**LEBANON PLANNING BOARD
DECEMBER 17, 2024 - 7:00 PM
COUNCIL CHAMBERS, CITY HALL OR
REMOTE VIA VIRTUAL PLATFORM
LEBANONNH.GOV/LIVE**

Re: The Brickyard Multi-family Planned Unit Residential Development (PURD)
174 Hanover Street Ext. & 238 Hanover Street (Map 48 Lots 1, 2, & 4 and Map 63 Lot 1)
Project Description and Impact Statement for Site Plan Review

Re: Proposed Multi-Family Development ("The Brickyard").
Site Plan Review Application
PUD/PURD Narrative Pieces

Layout and Materials
Plan 2

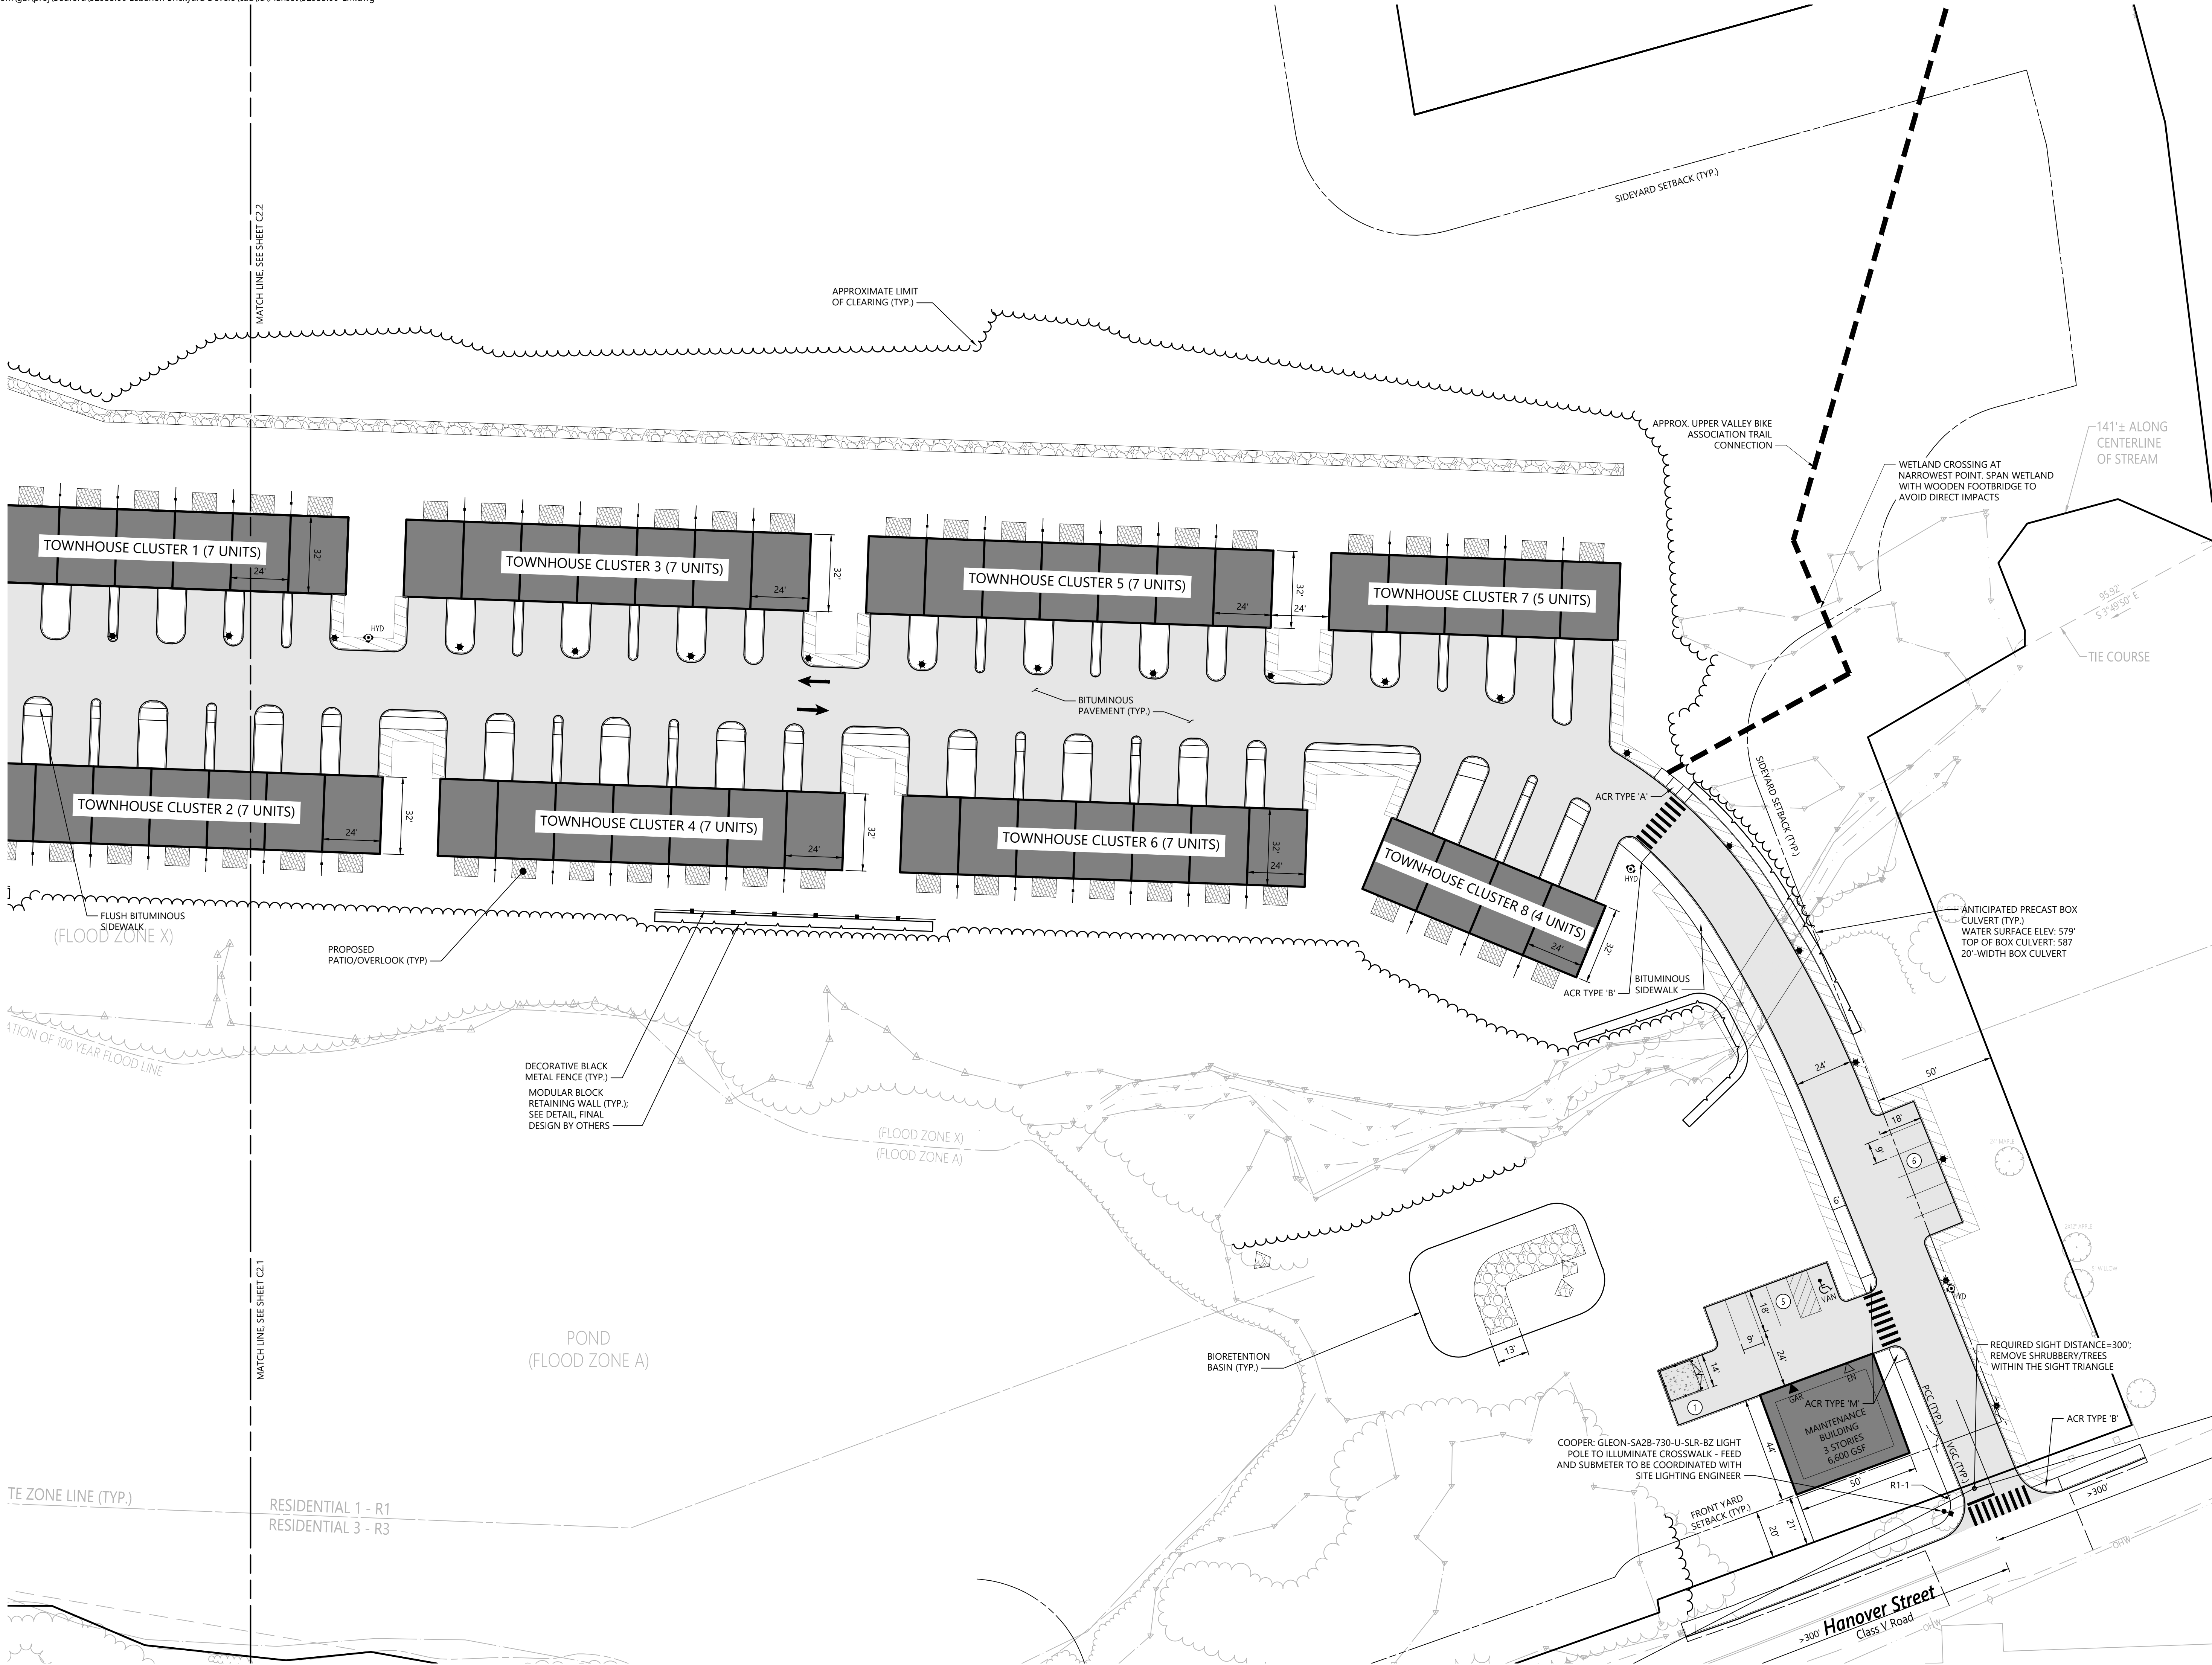
Comment 28. ***Sheet 8 (C2.2)***

Response: Locations for snow storage have been identified on sheets C2.1-C2.3.

Not Approved for Construction
Drawing Title
Layout and Materials
Plan 3

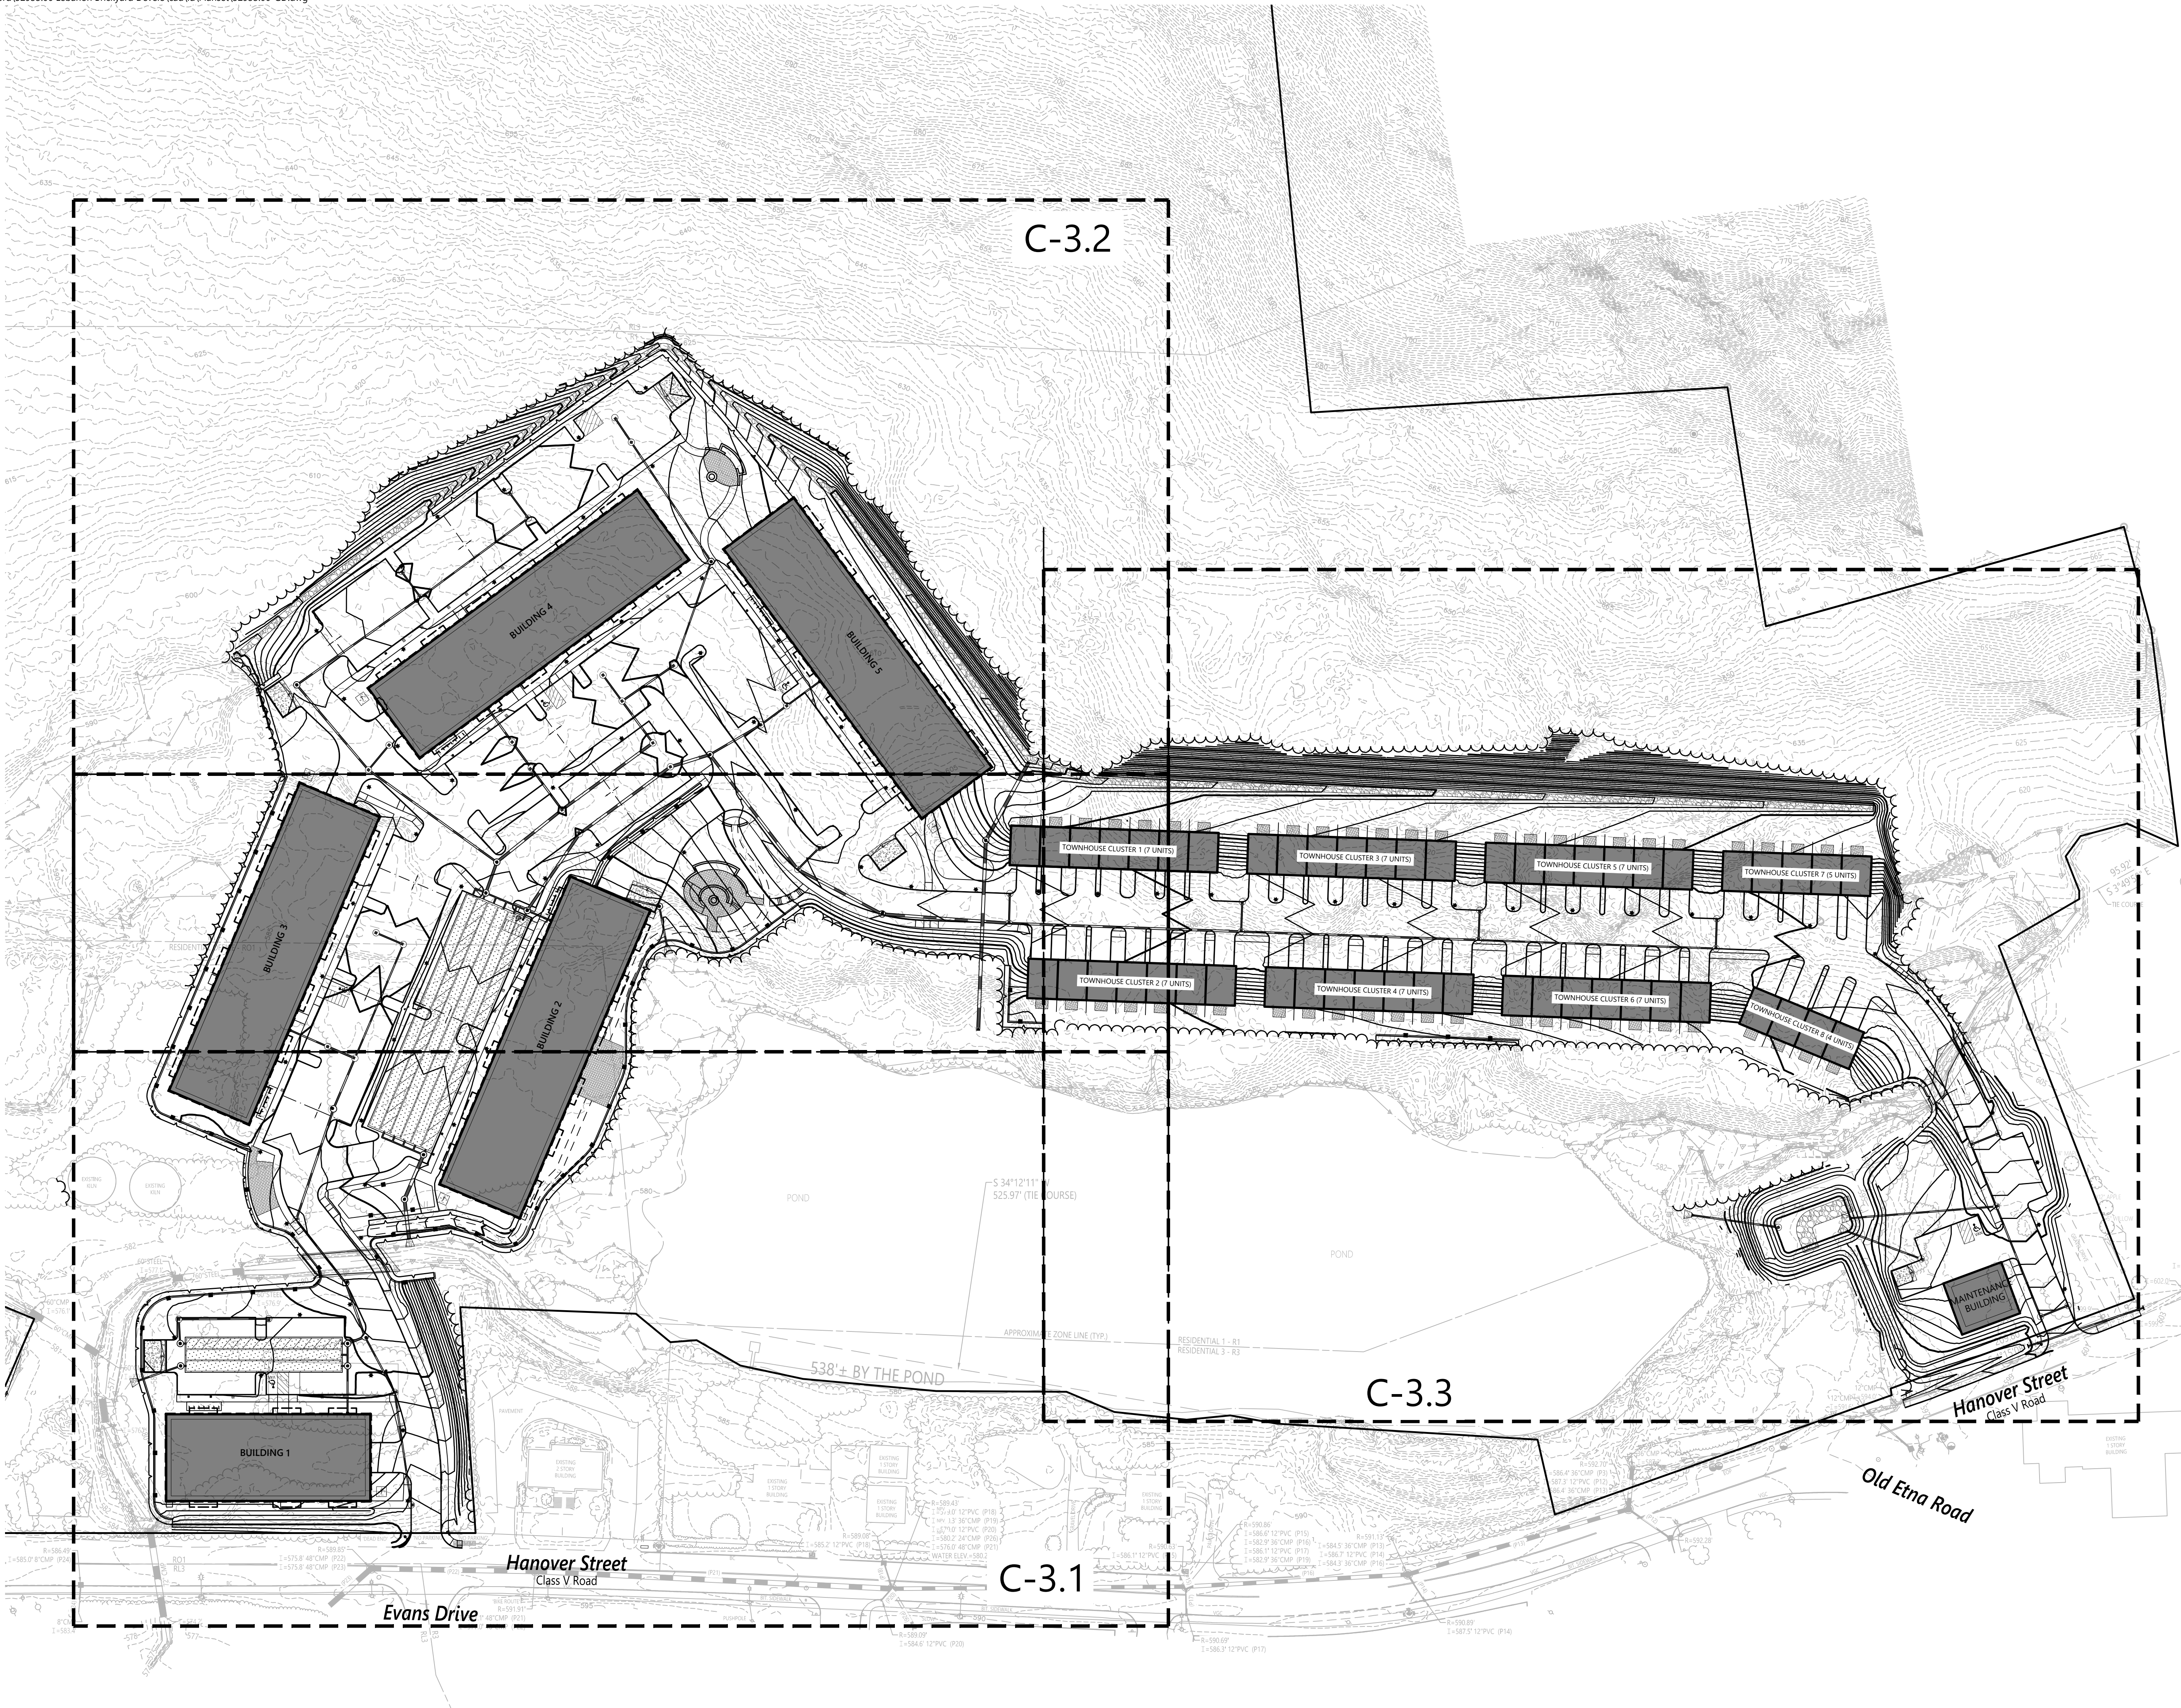
Comment 29. ***Sheet 9 (C2.3)***

Response: A note has been added to sheet C2.3.

Response: Locations for snow storage have been identified on sheets C2.1-C2.3.
